MAURKIT SUBDIVISION

APPLICATION NUMBER 6 DATE October 1, 2009

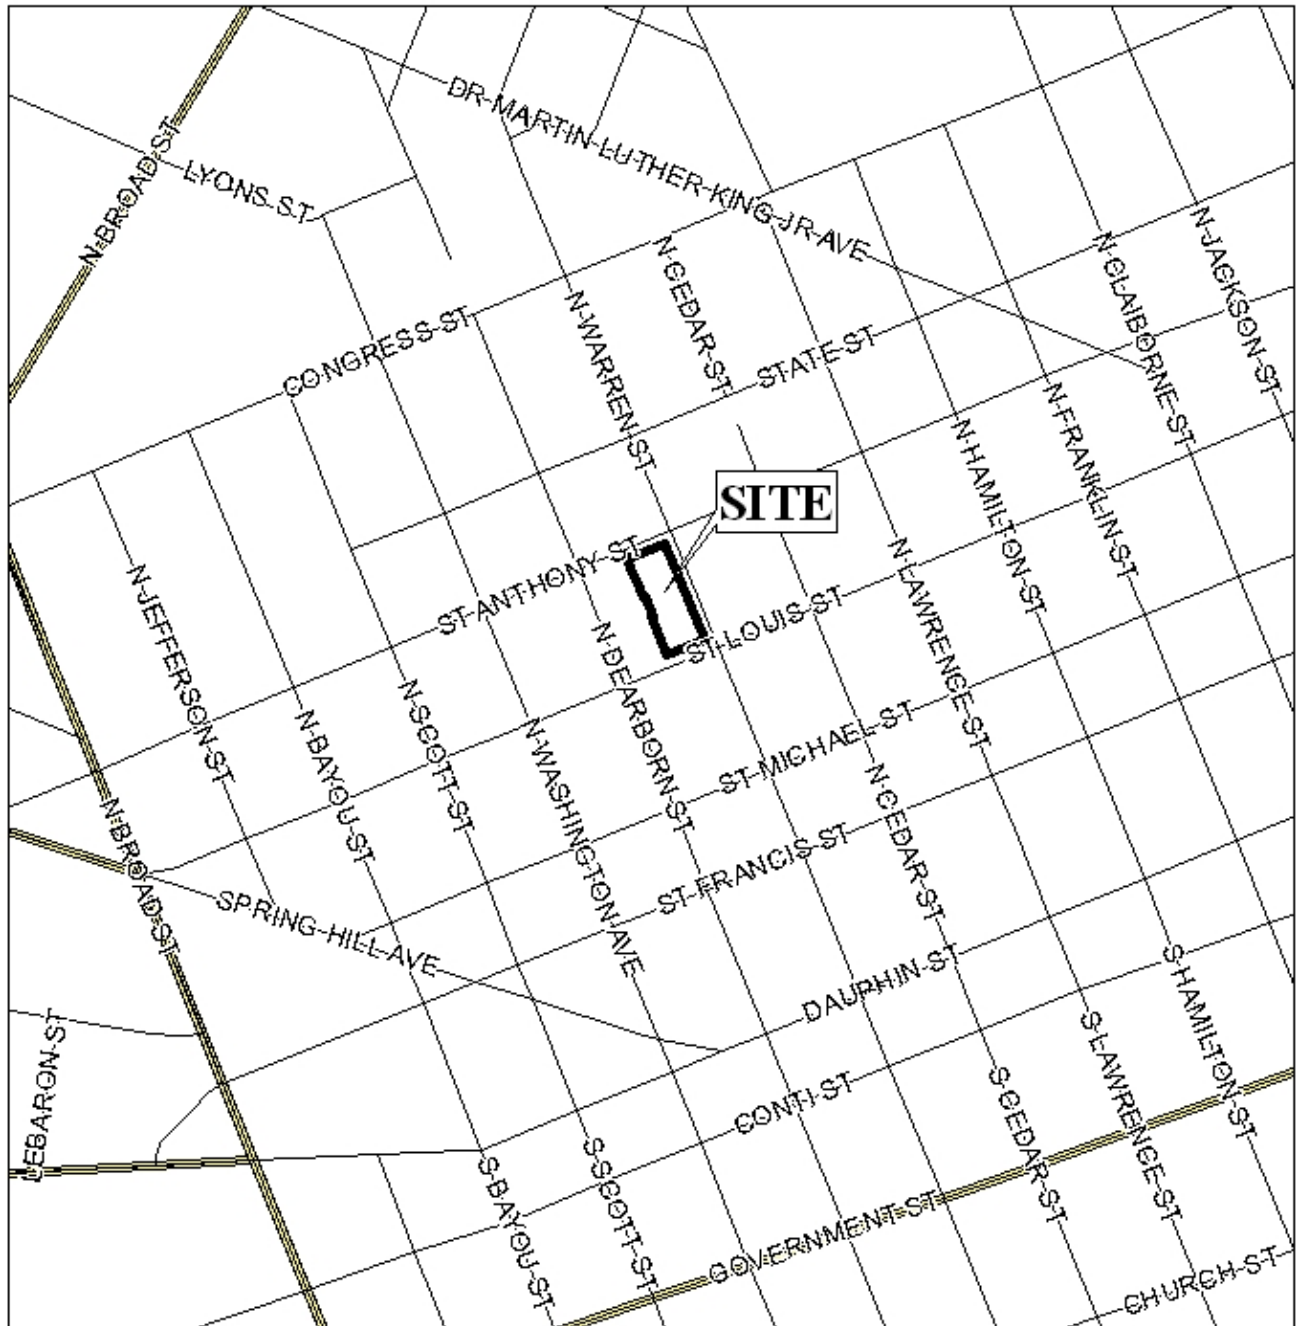
The proposed lots meet the minimum size requirements as regulated by Section V.D.2 of the Subdivision Regulations, however the proposed lot size is not indicated on the plat. The final plat should be revised to indicate the size of the lot in square feet or a table provided on the plat indicating the same, if approved. The proposed lots also have adequate frontage along a public right-of-way.

The intersection of St. Anthony Street and Warren Street has a structure built to the property line, which is allowed in B-4 zoning districts, making dedication to meet Section V.B.16 of the Subdivision Regulations regarding curb radii impractical. However, the same is not true at the intersection of St. Louis Street and Warren Street, and dedication sufficient to comply with Section V.B.16 should be required.

As the site is currently developed, and a lot line is depicted as dividing a building, full compliance with all building a fire codes should be required prior to the signing of the final plat. Compliance may include the construction of a fire-rated wall along the line dividing the building.

- 1) Provision of labeling of the size of the lot, in square feet, or provision of a table on the plat with the same information;
- 2) Dedication sufficient to comply with Section V.B.16 of the Subdivision Regulations at the intersection of St. Louis Street and Warren Street;

- 3) Full compliance with all building and fire codes to separate the buildings prior to the signing of the final plat;
- 4) Compliance with engineering comments: *Label each lot showing the required minimum finished floor elevation (MFFE). Must comply with all other storm water and flood control ordinances. Any work performed in the right of way will require a right of way permit. If a land disturbance permit is needed, any damaged sidewalk sections shall be replaced;*
